Office Action Summary	Application No. 10/757,776	Applicant(s) BOEHM ET AL.	
	Examiner DIANNE DORNBUSCH	Art Unit 3773

DETAILED ACTION

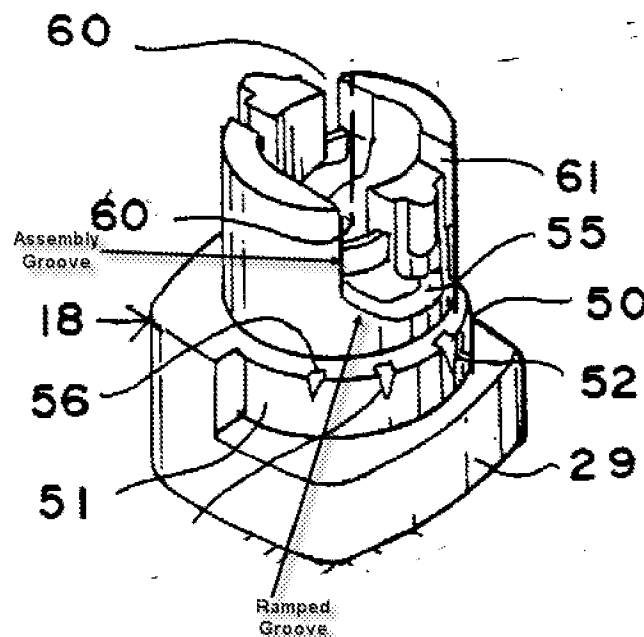
Morita discloses all the claimed limitations discussed above however, Morita does not disclose that the ramped groove is extending in a second direction deviating from the first direction in which the assembly groove extends.

Abulhaj discloses a lancet with an adjustable depth mechanism in which a cap (18) is adjustable by a pin/groove mechanism (Fig. 15-16 where the pin (31) enters the groove seen in the figure below) where the groove has an assembly groove (see figure below) extending in a first direction (it extends longitudinally from the proximal end towards the distal end) and a ramped groove (see figure below) extending in a second direction (it extends diagonally as seen in the figure below) deviating from the first direction (see figure below).

The substitution of one known element (the ramped and assembly groove of the threaded mechanism of Morita) for another (the ramped and assembly groove of the pin/groove mechanism of Abulhaj) would have been obvious to one of ordinary skill in the art at the time of the invention since the substitution of two well known connection mechanisms (pin/groove and threaded) which are used as depth mechanism such as the one shown in Abulhaj would have yielded predictable results of an adjustable depth mechanism.

Additionally, it would have been obvious to a person having ordinary skill in the art at the time the invention was made to provide Morita with the pin/groove mechanism that contains an assembly groove extending in a direction which is deviated from the direction of the ramped groove, in order to have an entry point for the pin which would allow the pin to slide straight through until the ramped groove is reached.

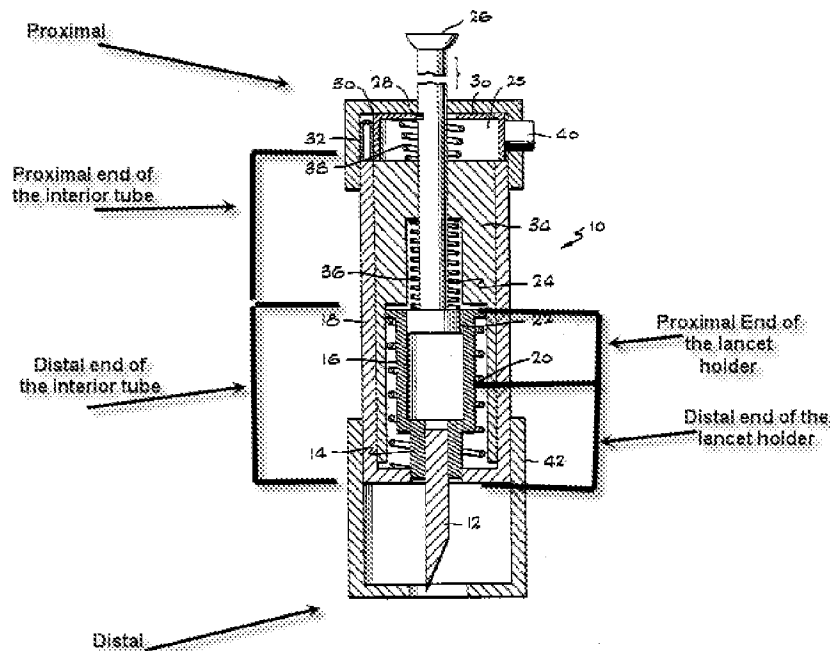
Claim 10: A rearward body assembly of a lancing device that can propel a lancet (12) into a lancing surface, the rearward body assembly comprising: a lancet holder (16)

comprising one or more retaining features (retaining features are the walls external of part 14 which compress the lancet in place) and one or more spring surfaces (the outer area and the top surfaces of the lancet holder are spring surfaces since the surface is in contact with the springs) at the distal end (see figure below where the distal end is labeled) and one or more lancet holding features (the internal wall of 14 and 16 as seen in the Figure) at the proximal end (the proximal portion of the holding features is at the proximal end as define din the figure below); an interior tube (34) comprising an open end (proximal end as seen in the Figure) and a slotted end (distal end where it is stepped as seen in the Figure) through which the one or more retaining features extend (see the Figure), the interior tube (34) being adapted to slidably engage the lancet holder (16) (the lancet holder is placed inside the inner tube as seen in the Figure); a finger cover (18) (note that the finger cover according to applicant's drawings is a collar that goes over the interior tube as best seen in Fig. 3 of the current application) arranged along a periphery of the interior tube (see Figure); an internal compression spring (36) comprising a first end and a second end (see Figure), the first end of the internal compression spring (36) being adapted to act on the slotted end of the interior tube (34) (the proximal end of the spring is in contact with the slotted area as seen in the Figure) and the second end of the internal compression spring (36) being adapted to act on the one or more spring surfaces of the lancet holder (16) (the distal end is in contact with the lancet holder so when a force is applied on the spring it will act on the spring surfaces); a retainer (14) comprising a slotted surface (it has a slot in the center where the lancet is slid through) at the distal end of the interior tube (see figure below)

through which the one or more retaining features extend (see the Figure); a rearward body (combination of 24 and 22), the rearward body engaging the retainer (14) (when the rearward body is displaced in the forward direction it will engage with the retainer); wherein longitudinal movement of the rearward body away from the interior tube compresses the interior compression spring (36) (by pulling on the rearward body it can compress the interior tube) (Col. 3 Lines 5-10) and an external compression spring (20) comprising a first end and a second end (see the Figure), the first end comprising a reduced coil diameter that engages the one or more retaining features (14) of the lancet holder (16) as seen in the Figure, the first end of the external compression spring being adapted to act on the lancet holder (the spring is holding the lancet holder which will act on it to cause the deployment of the lancet) and the second end of the external compression spring being adapted to act on the slotted surface of the retainer (the spring is compressing on the retainer therefore it is acting on the slotted surface); and wherein the one or more spring surfaces of the lancet holder engages both the internal compression spring and the external compression spring (see Figure where the one or more spring surfaces engages indirectly to both spring).

not at the proximal end. The examiner disagrees as explained in the rejection and drawing above. Note that the applicant did not disclose a specific definition of the distal and proximal ends of the device with respect to the components of the device therefore the examiner broadly interpreted it and defined the distal and proximal end as seen in the drawing above.
